Product Change Notification

PCN-ICC-2561-2018

Business Unit	Product Line Code	Type of Change	Action	Date of Issue
ICC - Industrial Cabinet	BE2	Product Change Notification	Notify Distributors and Field	10/3/2018

Description for Product Change Notification

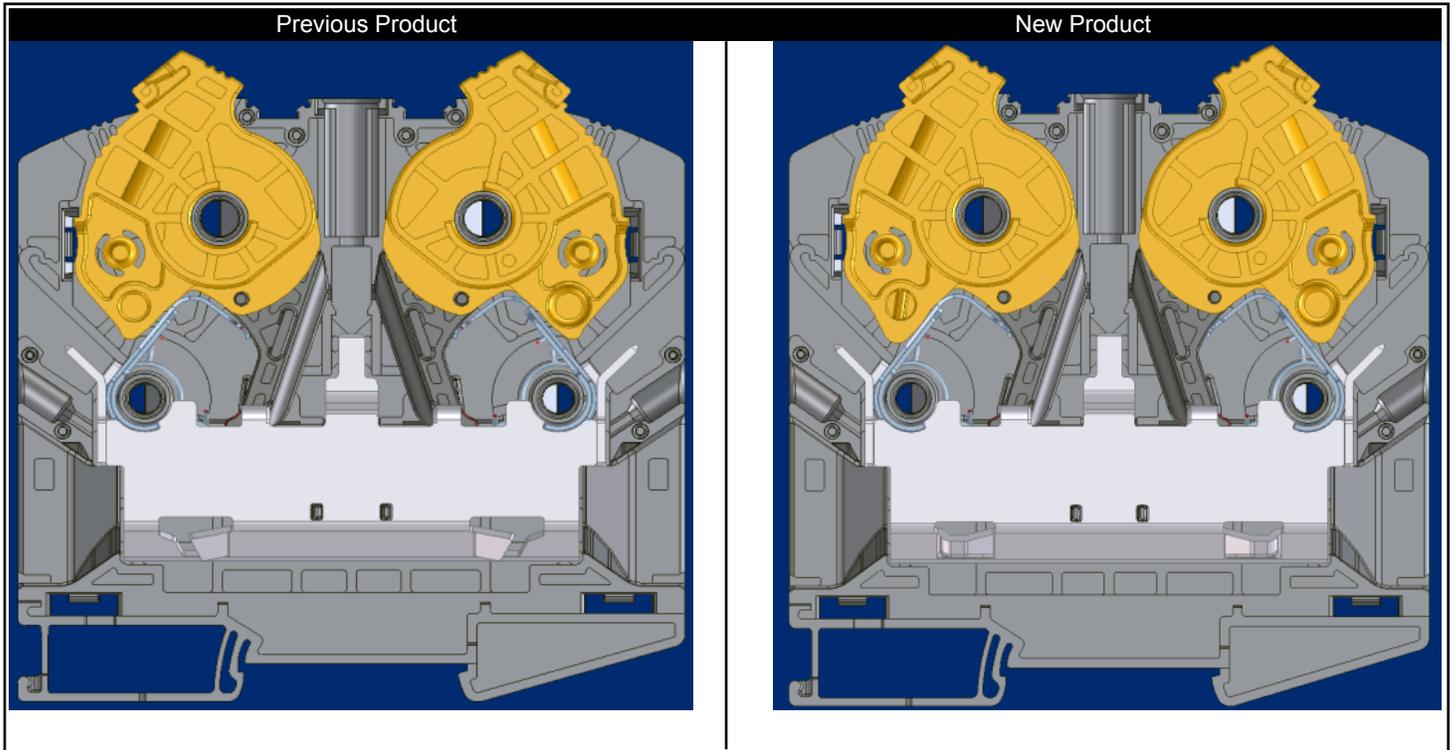
Small changes have been made to the design of the spring and some additional material in the PowerTurn lever of PTPOWER 50 to improve the contact force the block is capable of. The changes are not visible in the housings from the outside or top of the block. No change in form, fit, or function.
